Design Advisory Board

Tuesday, November 12, 2024, 3:00 PM

To: Design Advisory Board
From: Garret King
Re: 573 South Willard Street
Date: November 12, 2024

To: Design Advisory Board
From: Garret King
Re: 46 North Willard Street
Date: November 12, 2024

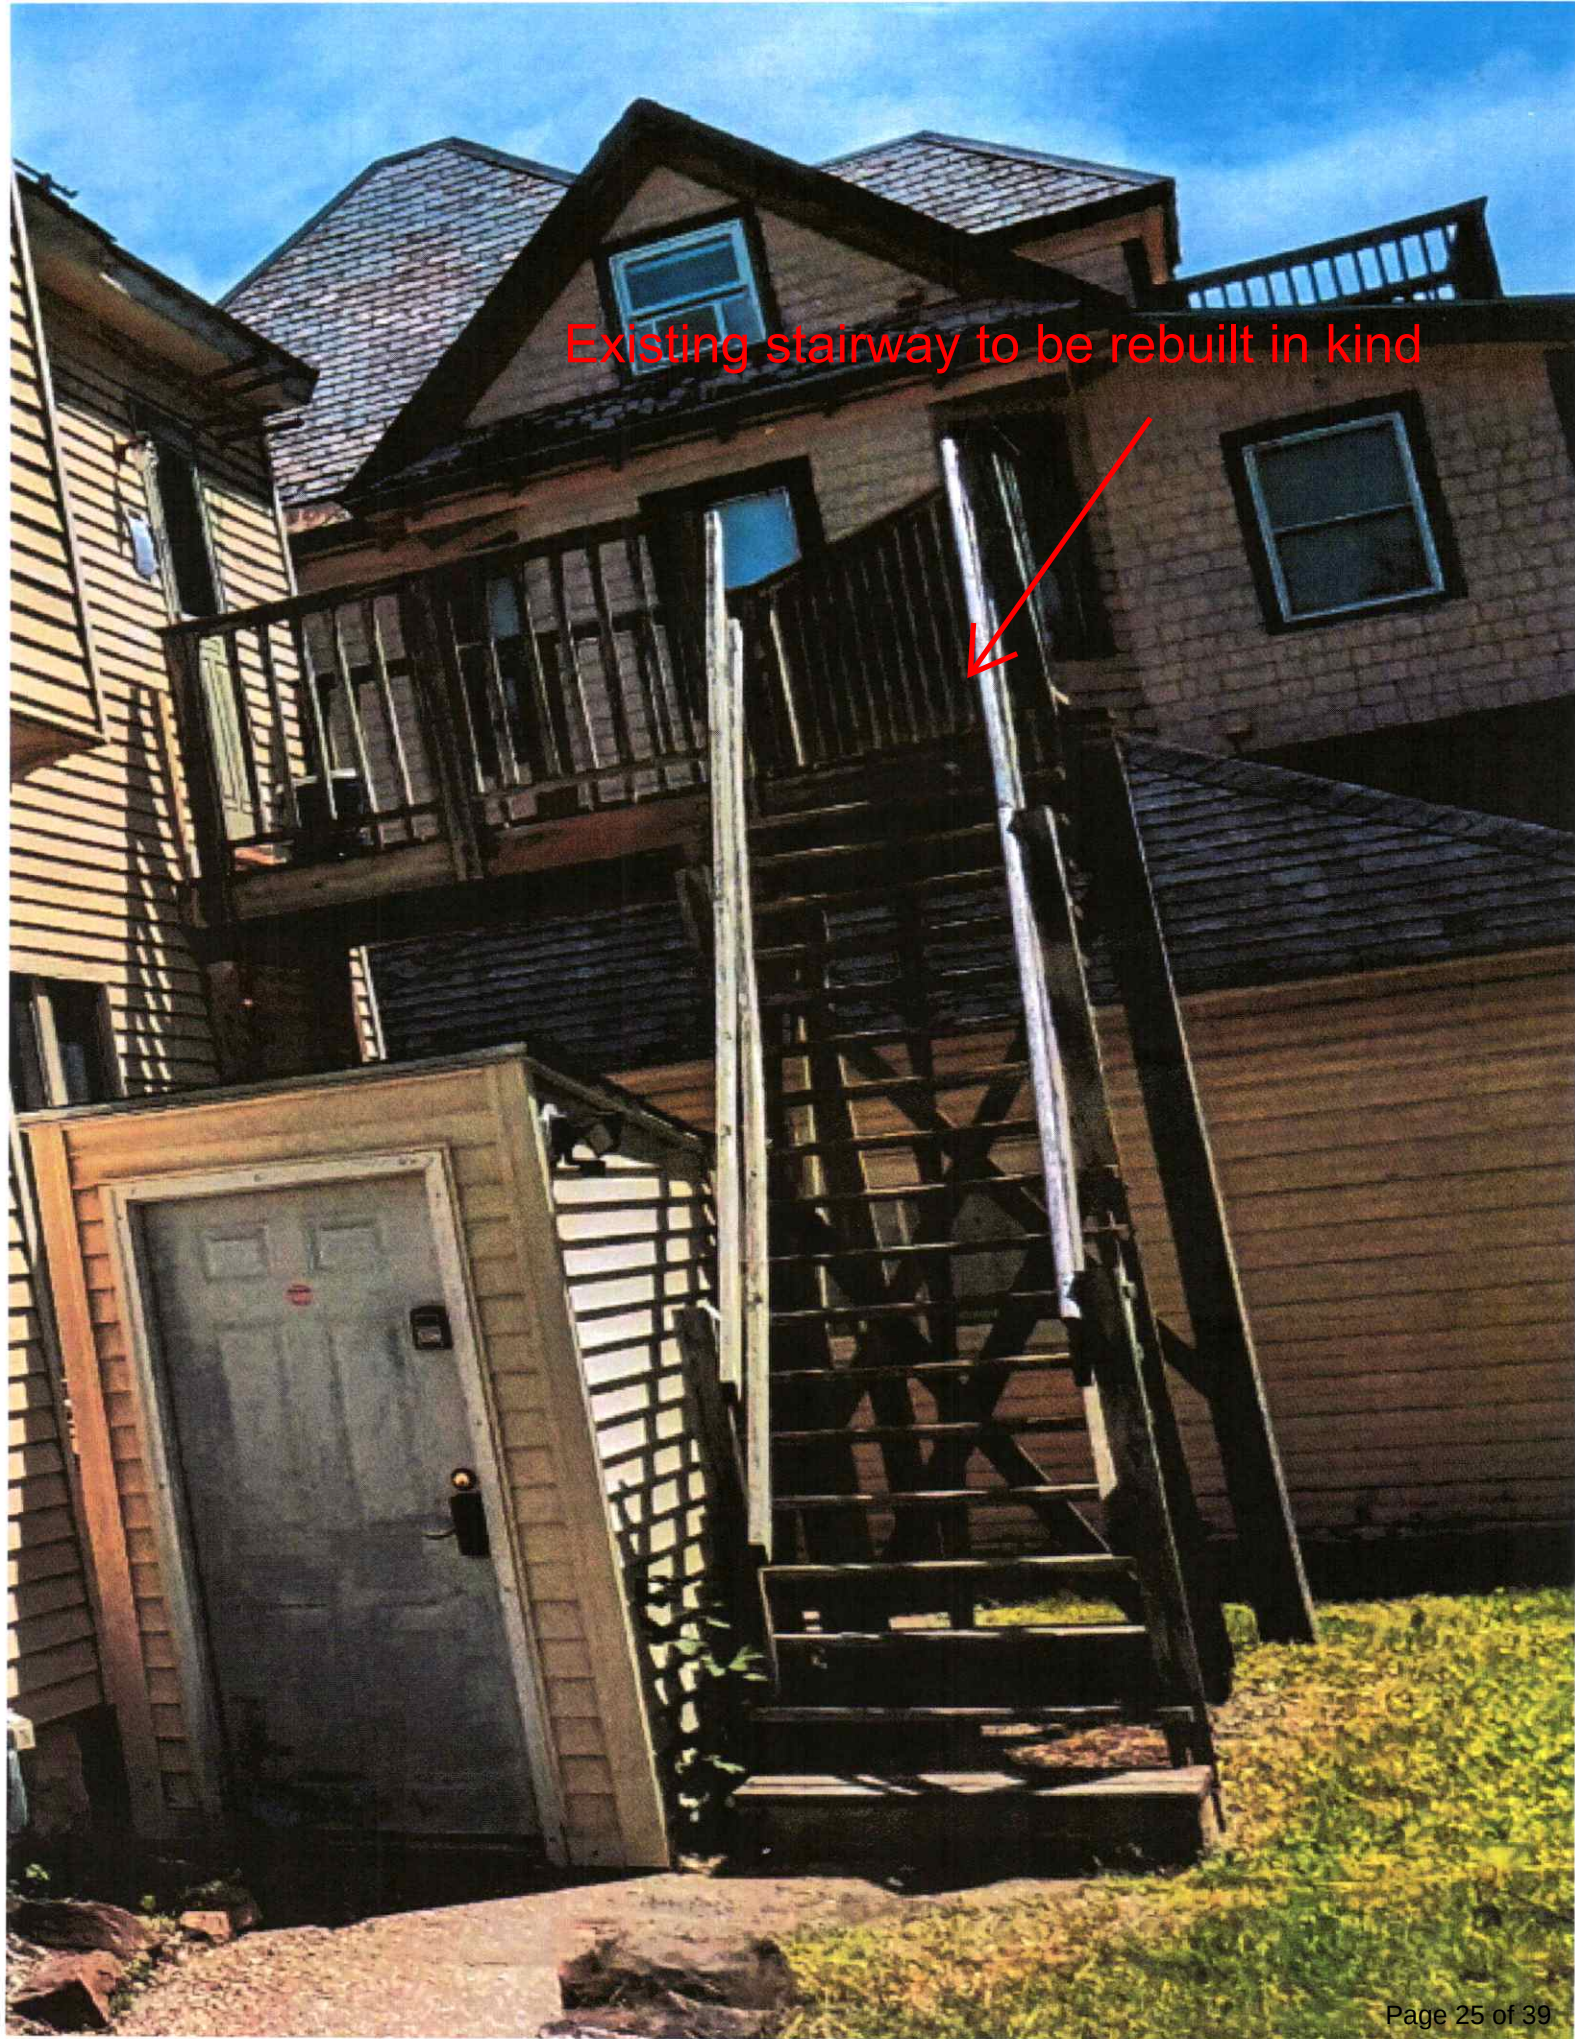
The application has come to the DAB for review of the removal of the north elevation second story porch and associated door. The porch has already been removed due to safety concerns. The applicant wants to keep the porch removed if possible and seal up the door with siding to match the rest of the building.

The proposed removal of the second story porch will be removing a distinctive feature of the building that is explicitly noted on the historic listing. The proposed siding to be used for infill would match the existing siding of the building.

While the original form of the building has been retained, the removal of a distinctive feature is inconsistent with the purpose of this criteria.

The second story porch has already been removed as it was deteriorated into a potential safety hazard. With the second story porch already removed only replacement is possible.

Require the reconstruction of the second story porch as it is a distinctive feature explicitly noted in the historic listing of the property.

Reference image
of old porch

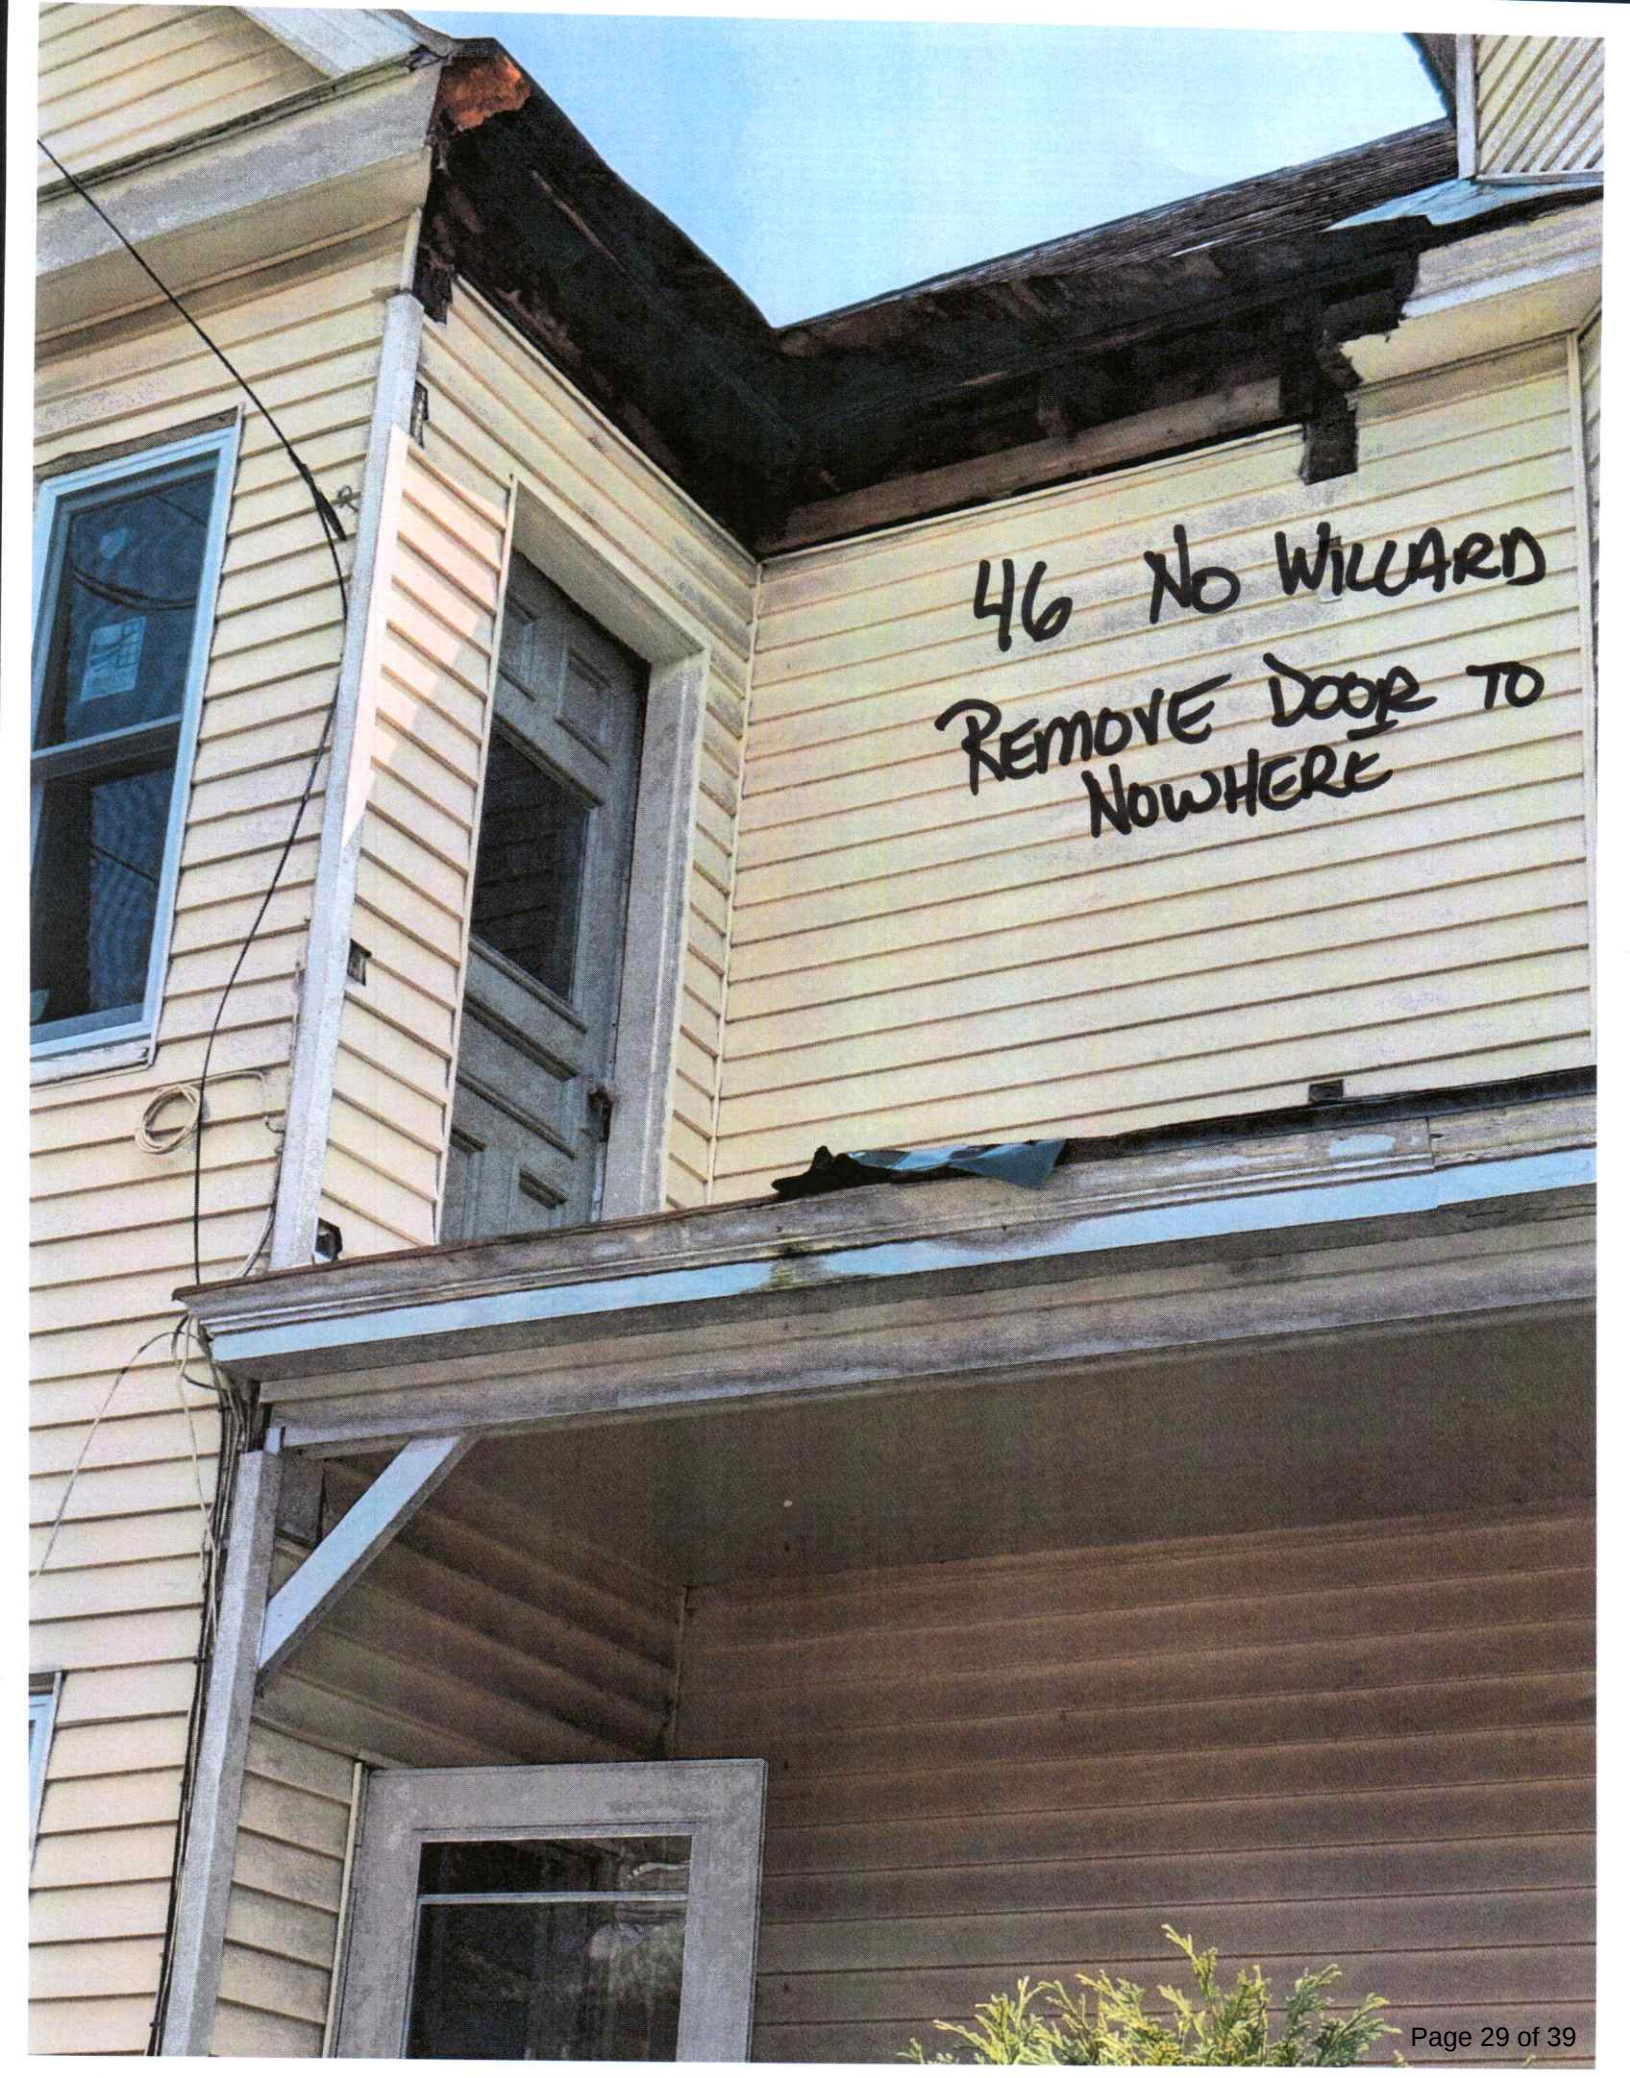
~~REMOVE UNPERMITTED
ENTRANCE~~

After the Fact entrance to remain

~~REMOVE~~

REMOVE
DOOR

46 NO WILLARD
REMOVE DOOR TO
NOWHERE
